Comments on GW contours

Comments on GW Monitoring

FIGURE 3.6

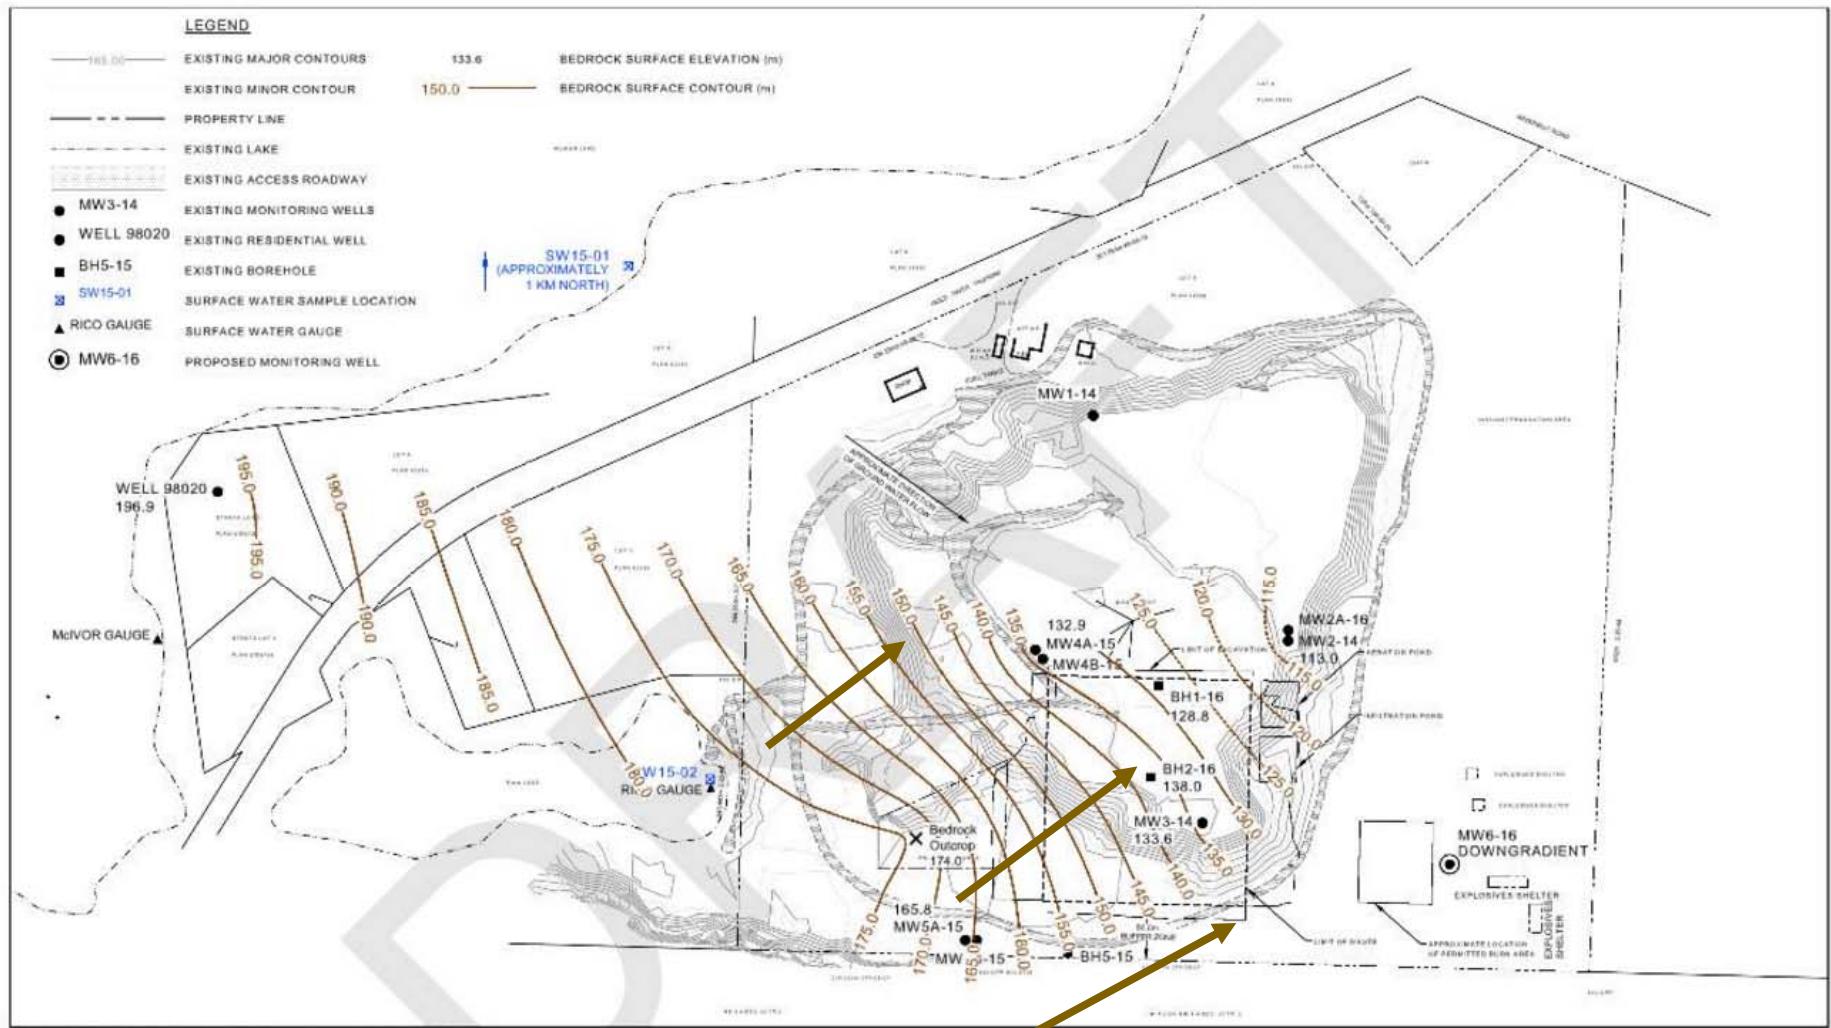
- GHD groundwater contours are limited by a lack of borehole data to the West and East of the site.
- **Aquifer conditions and hydraulic gradient to the East of site are poorly understood.**
- GWS modelled the hydraulic gradient using all available groundwater elevations. Our analysis does NOT match that of GHD.
- ***Proposed* MW location may not actually be downgradient of infiltration pond.**

Hydraulic Gradients

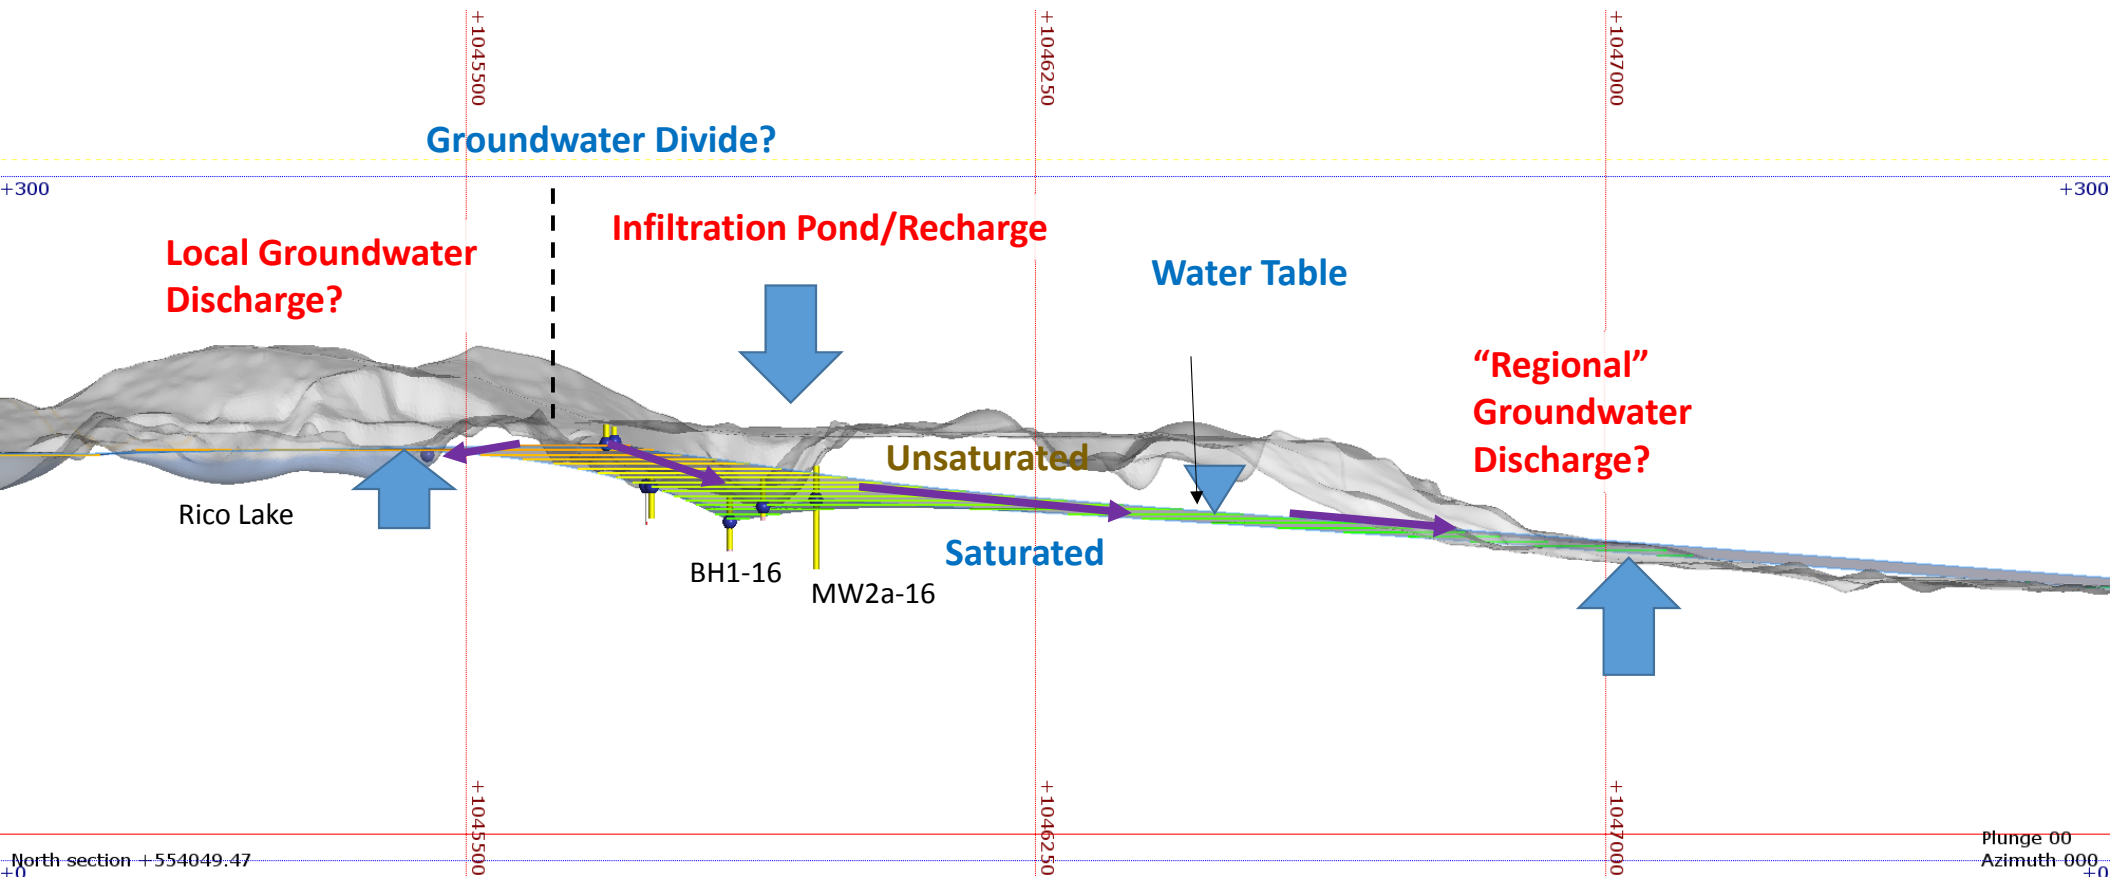
- There is insufficient characterization of the groundwater regime at both the eastern and western property boundary.
- Groundwater transiting the property has the potential to “daylight” approximately 2 km east of the site in wetlands and small tributaries to Quinsam River.
- Due to the high permeability of the aquifer, the recommended groundwater quality monitoring wells may be inadequate in number and location to intercept a potential plume emanating from the site.
